Technical BULLETIN

ALL 2008 PZ50GTX/MTX MODELS

Insufficient Heat Output from Grip Warmers

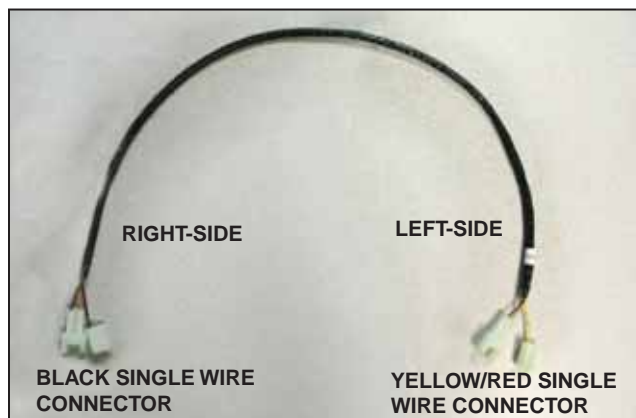
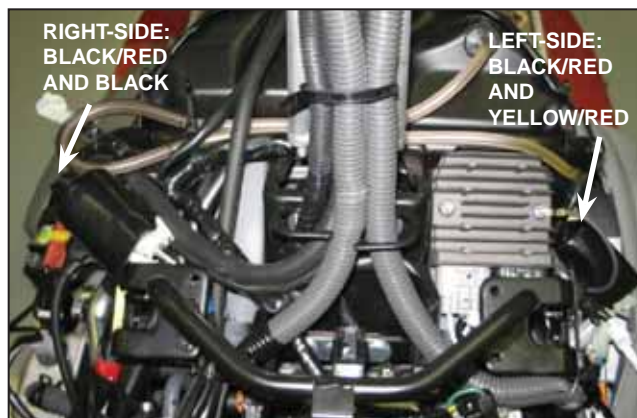
1. Remove the windshield.
2. Remove the headlight cover. Remove the 3 bolts, on each side of the unit, to remove the left and right side panels.
3. Remove the headlight assembly and the fuel tank cover.
4. Locate the grip warmer wire harness connectors, on both sides of the unit, inside the rubber boots (see adjacent photo).

5. Disconnect the two grip warmer connectors.
6. Identify the left and right sides of the grip warmer sub-harness wire (see adjacent photo).
LEFT-SIDE: Yellow/Red single wire connector.
RIGHT-SIDE: Black single wire connector.
7. On the right side of the unit, insert the sub-harness through the back of the rubber boot, then connect it to the main harness and grip warmer as shown in the wiring illustration adjacent to step 10 on the next page.

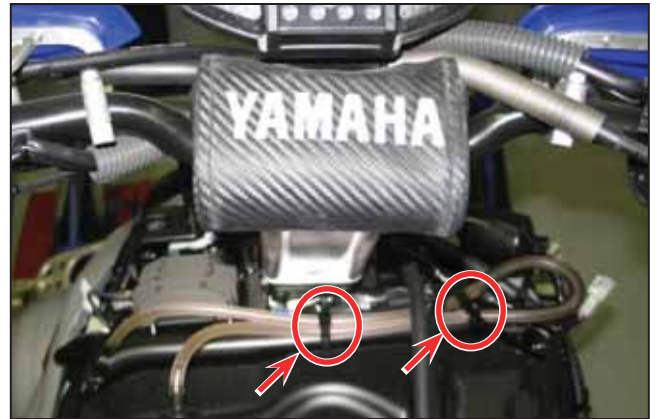
8. To route the new sub-harness, loosen the two plastic wire clamps that secure the fuel tank vent hoses to the steering gate (see adjacent photo). Install the sub-harness along the steering gate and behind the steering column. Retighten the plastic wire clamps as shown.

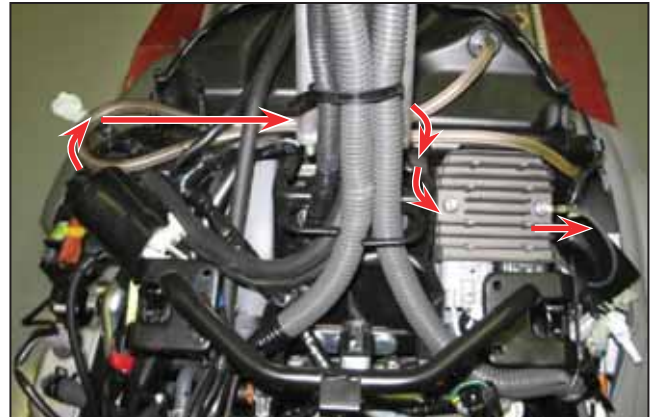
9. Position the sub-harness inside the wire holder following the main harness routing (see adjacent photo). The sub-harness should be routed behind the regulator/rectifier.

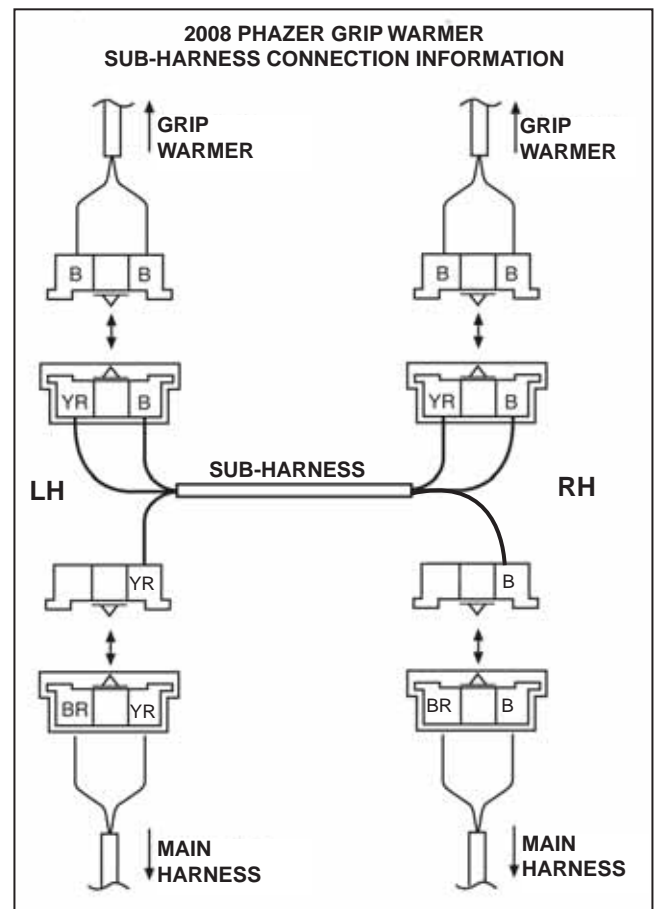
10. On the left side of the unit, insert the sub-harness through the back of the rubber boot and then connect it to the main harness and grip warmer as shown in adjacent wiring illustration.
